**CONWAY**  
HISTORIC DISTRICT COMMISSION  
JANUARY

## **CONWAY HISTORIC DISTRICT COMMISSION MEETING**

## OLD CONWAY DESIGN OVERLAY DISTRICT CERTIFICATE OF APPROPRIATENESS DEXTER COVERED CARPORT 1623 BRUCE STREET

**OLD CONWAY DESIGN OVERLAY DISTRICT  
CERTIFICATE OF APPROPRIATENESS  
SPRUCE STREET COTTAGES,  
A COTTAGE POCKET NEIGHBORHOOD  
710 SPRUCE STREET**

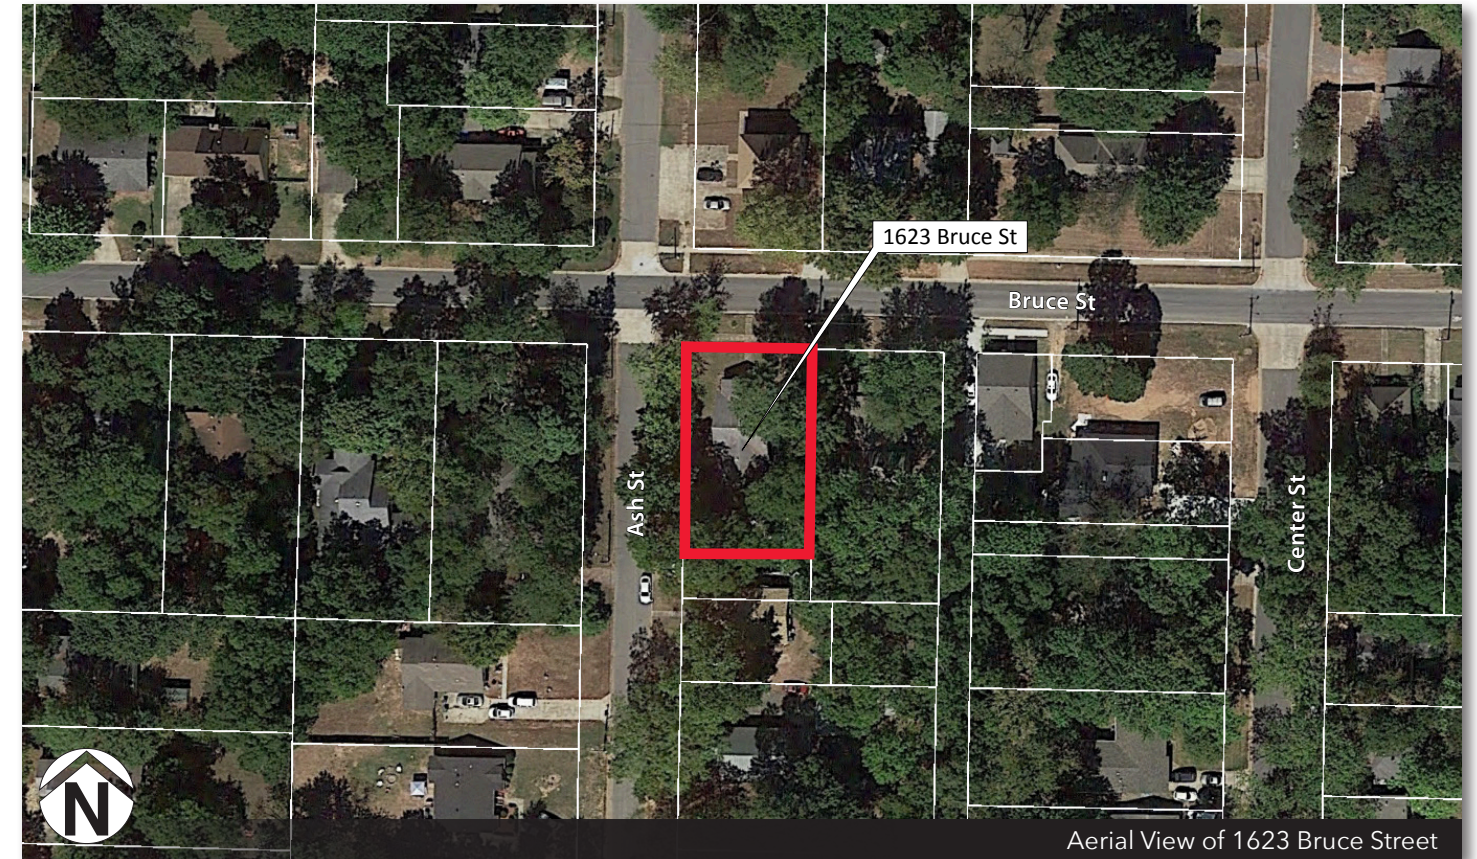
The applicant constructed an open, 230 square foot, 2 car carport cover on the west side of their single family residence. A building inspector discovered the cover at near completion and informed the residents that a building permit and Historic District Commission approval was necessary. The carport cover is constructed of wooden beams, rafters, and posts. The posts measure 5" x 5". It has a metal shed roof that is largely invisible from the streets.

**Setbacks.** Proposed setbacks should respect the predominant setbacks of area structures, especially the front setback. Front setbacks are allowed within a range of 80% to 110% of the average area front setback. The west setback from the carport cover is approximately 21 feet from the curb. This places the cover out of the street right of way and on private property. It appears that the property line is 19 feet from the curb. The setback is about 2 feet from the west property line. Ash Street has an extra wide 60 foot right of way. There are no other structures along Ash Street this close to the property line, however there is precedent in the area for structures within 2-3 feet from the property line; 1615 Bruce Street and 1722 Simms Street are examples..

**Orientation.** The direction in which the front of a building faces. The carport faces Ash Street the front facade orientation of the residence is not affected.

Staff recommends approval of the addition, open carport, and driveway with the following condition:

The carport and additional driveway shall be allowed to remain as constructed approximately 21 feet from the base of curb.

Aerial View of 1623 Bruce Street

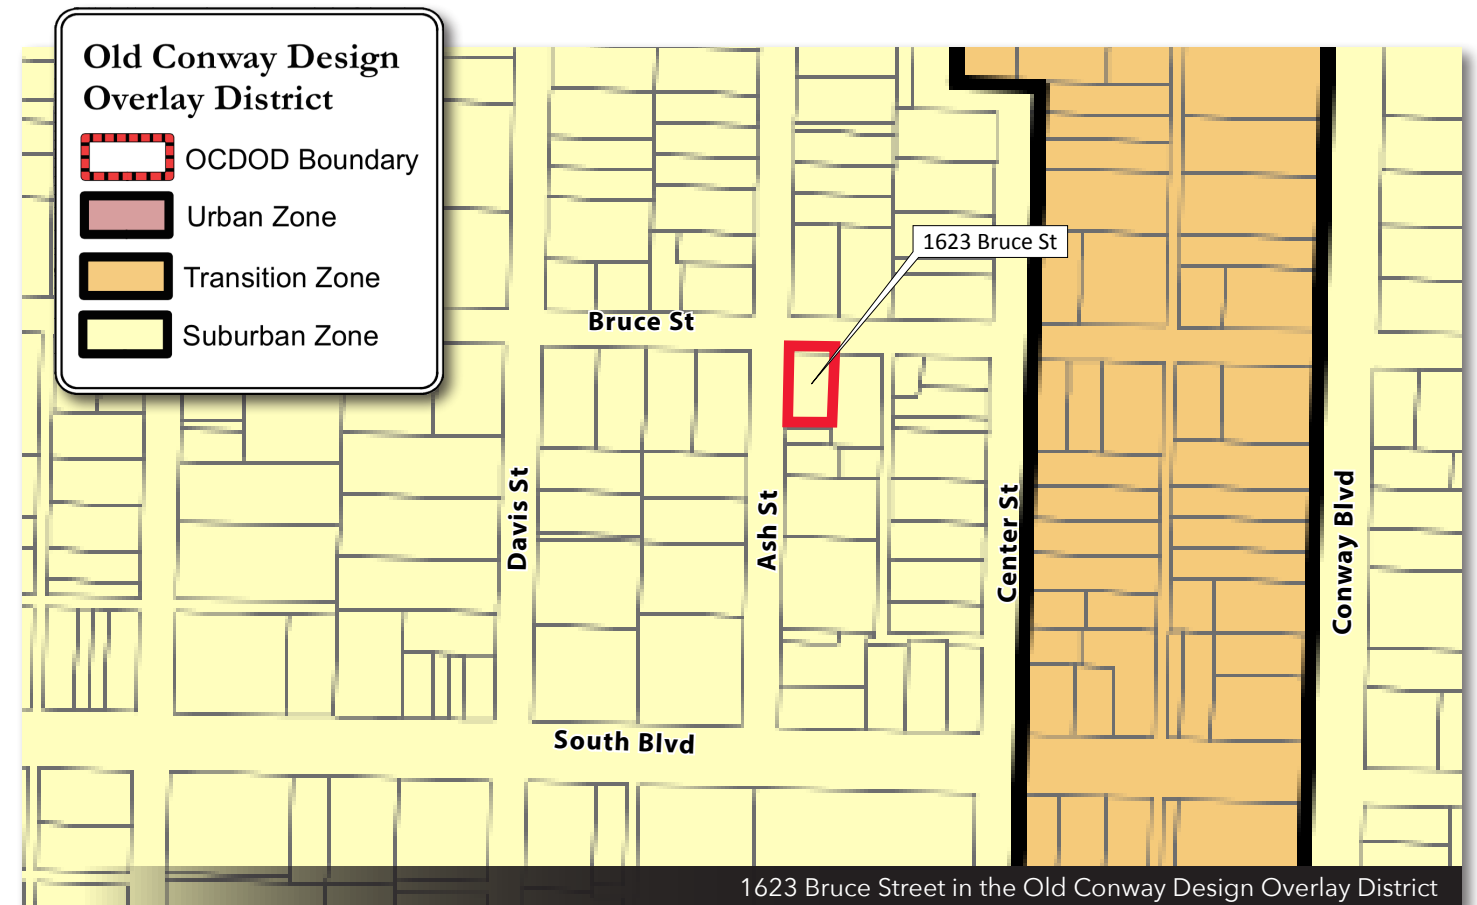
**Tree preservation.** A fairly large sweet gum tree was removed to provide additional driveway area. This tree was one of four significant trees along the west property line. No remedial tree seems necessary. A line of overgrown hedges were removed as part of recent upgrades to the residence. The overall landscaping appearance has been greatly improved.

SPRUCE STREET COTTAGES  
SITE PLAN

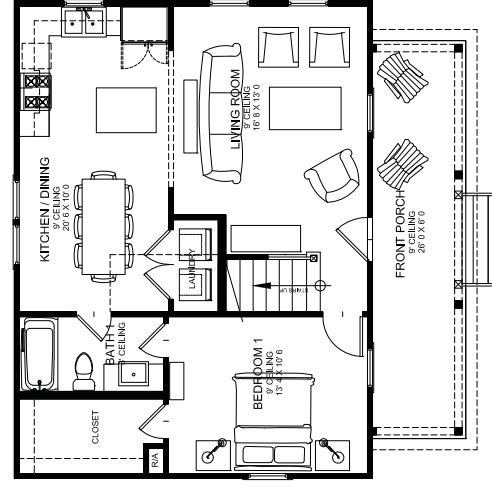
**Setbacks.** Area regulations were amended to allow the minimal setbacks necessary for a cottage pocket neighborhood. The reduced setbacks as shown on the plan are within the allowed requirements.

**Orientation.** The direction in which the front of a building faces. Cottages 3, 10, 6, and 7 face Hamilton and Factory Streets. Cottages 11 and 14 face Spruce Street. Cottages 4, 5, 8, 9, 12, and 13 face the interior promenade and green space.

**Driveway / Parking.** The east/west alley provides access and 17 parking spaces on the north side of the development. Cottages 11, 12, 13, and 14 have garages. There should be ample off street parking for the residents and visitors.

**Tree preservation/Landscaping.** The lot was recently cleared of underbrush and dead trees. Several large trees were preserved. A dense cottage neighborhood will need to be extensively landscaped in order to provide privacy and better define public/private areas. Trees as shown on the plan will be sufficient to provide the necessary level of screening and definition. Additional shrubs and plants should be placed where it is appropriate.

1. The development shall be built as proposed on the submitted plans. HDC Staff shall be allowed to make minor adjustments of landscaping, structure placement, etc as the project is constructed.
2. Vinyl siding shall be allowed. However, traditional wide trim details shall be used around all windows and doors.
3. Trees shall be planted as shown as a minimum. Additional trees and shrubs as necessary to provide additional privacy, screening, and aesthetic appeal are encouraged.

'Damon' House Design

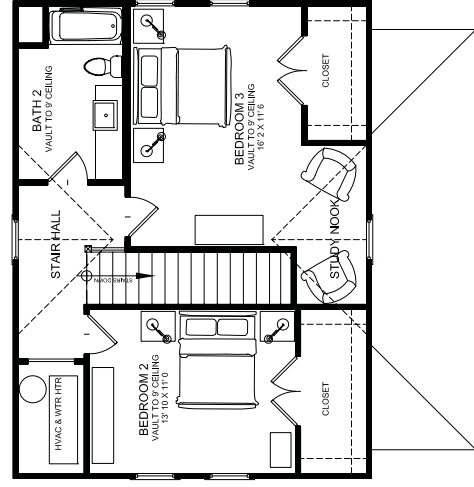
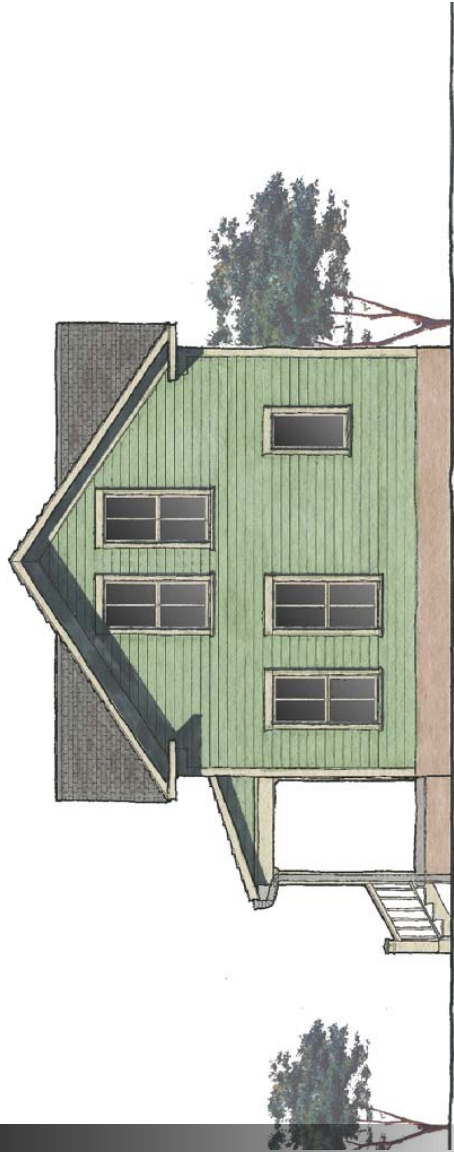
**Style.** The proposed cottage style could be describes as traditional southern vernacular cottage. The 4 proposed cottage plans are varied yet maintain a style that unifies the entire development. Entries, Porches, and Porticos. All cottages have front porches. Old Conway regulations state that a porch must be 6 feet in depth. The proposed porches are shown as at least 6 feet and are appropriate. Porch columns appear to have an appropriate width.

Synthetic materials such as vinyl, aluminum, and synthetic stucco (EIFS products) are not historic cladding materials and should not be used. The cottages are shown clad with a ship lap siding and traditional wide trim boards around windows and doors. In order to keep the structures affordable, a high quality vinyl siding is proposed. The type of exposed foundation material is unclear.
